Date: February 11, 2021

To: Planning Board
From: Lincoln Daley, Community Development Director

Subject: B33 Lordens Plaza, LLC (owner) and St. Mary's Bank (applicant), Tax Map 44, Lot 6, 586

**Nashua Street.** Review for acceptance and consideration of final approval for a site plan to renovate the existing bank building on the newly subdivided parcel with an additional bank drive aisle and 182 square foot building expansion. The parcels are located at 586 Nashua Street in the Commercial 'C'

GRADING, DRAINAGE & UTILITY **PLAN**

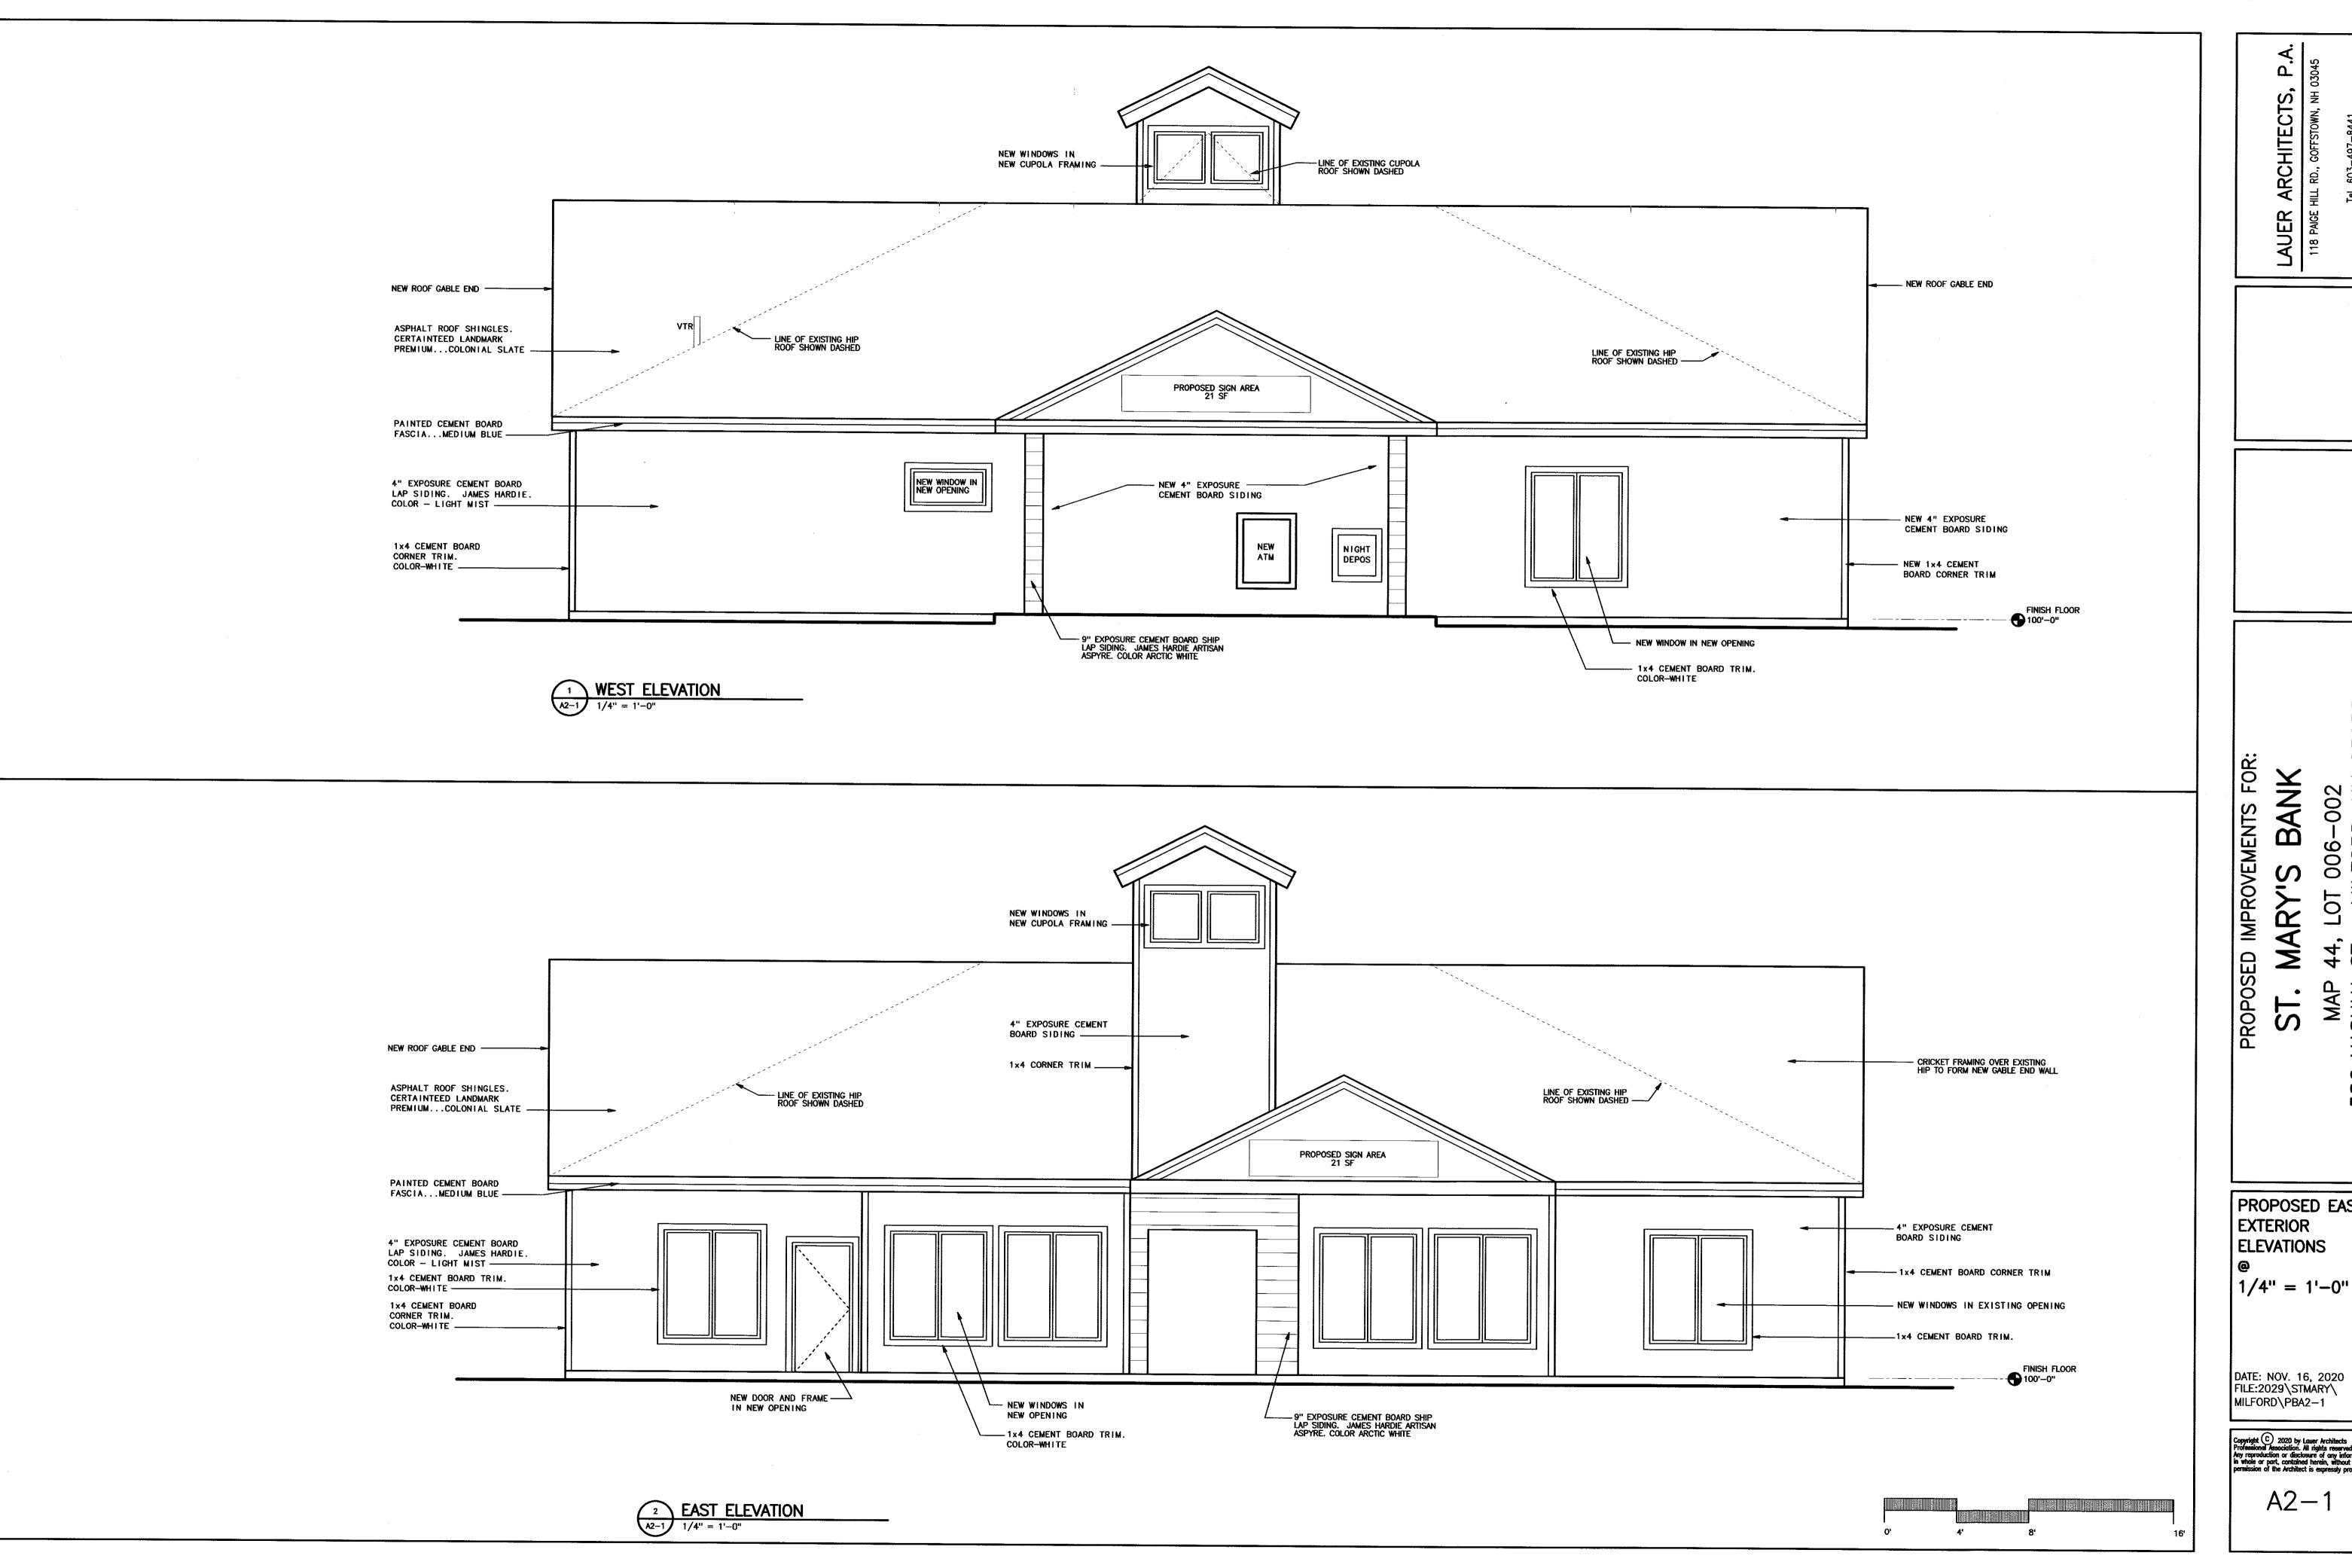
The applicant has provided a revised plan sheet 6 entitled Grading, Drainage, & Utility Plan. The project will utilize the existing grading, stormwater, and drainage design and infrastructure to manage onsite stormwater. Cross easements have been constructed to allow the applicant to continue utilizing the existing parent lot stormwater structures.

**Environmental Programs/Stormwater:** The applicant has revised the site plan to include a drainage/stormwater management design. The project area will be graded/laid out to utilize the existing catch basins to manage stormwater. See Sheet 6 – Grading, Drainage, & Utility Plan. Cross easements have been constructed to allow the applicant to continue utilizing the existing parent lot stormwater structures. Staff has no issues.

REVISIONS:				
REV:	DATE:	COMMENT:	BY:		
1	2/11/21	REVS PER TOWN COMMENTS	DGM
